Access Compliance Report

Public Rights-of-Way

(Island Curb Cuts)

Intersection ID: 52790	Main Street: COLEMON_KERRY_DR	Cross Street: FRIENDSHIP_VILLAGE_PL	Location: S
ADA ID: 2B7A9A3A9295	Curb Cut Type: MedianRefuge2	Initial Pass/Fail: Pass	Overall Compliance: No
Severity Score: 15.25			
Codes/Mitigation Info/Possible Solution		Field Measurements/Component Compliance

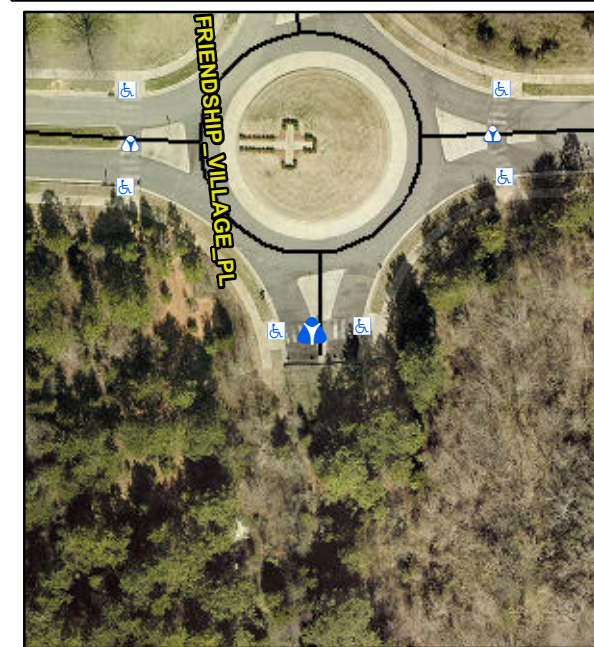
Compliance	Description	Data	Compliance	Description	Data
No	Refuge 1 Length (In)	35.5	Yes	Gutter 1 Ponding?	No
Yes	Refuge 1 Width (In)	120.0	Yes	Gutter 1 Lip Ht (In)	0.0
Yes	Refuge 1 Slope (%)	3.6	No	Gutter 1 Slope (%)	N/A
Yes	Refuge 1 X Slope (%)	0.7	No	Gutter 1 X Slope (%)	N/A
N/A	Painted X Walk1?	No	Yes	DWS 1 Provided?	No
N/A	X Walk 1 Direction	To W	N/A	DWS 1 Contrast?	No
N/A	X Walk 1 Width (In)	N/A	N/A	DWS 1 Length (In)	N/A
N/A	Road 1 Slope (%)	1.0	N/A	DWS 1 Full Width?	No
N/A	Road 1 X Slope (%)	3.1	N/A	DWS 1 Offset (In)	N/A
No	Refuge 2 Length (In)	35.5	N/A	Gutter 2 Ponding?	No
Yes	Refuge 2 Width (In)	120.0	N/A	Gutter 2 Lip Ht (In)	N/A
Yes	Refuge 2 Slope (%)	1.3	N/A	Gutter 2 Slope (%)	N/A
Yes	Refuge 2 X Slope (%)	0.4	N/A	Gutter 2 X Slope (%)	N/A
N/A	Painted X Walk2?	No	Yes	DWS 2 Provided?	No
N/A	X Walk 2 Direction	To E	N/A	DWS 2 Contrast?	No
N/A	X Walk 2 Width (In)	N/A	N/A	DWS 2 Length (In)	N/A
N/A	Road 2 Slope (%)	0.8	N/A	DWS 2 Full Width?	No

Remove & Replace Entire Refuge.
Remove & Replace Gutter.
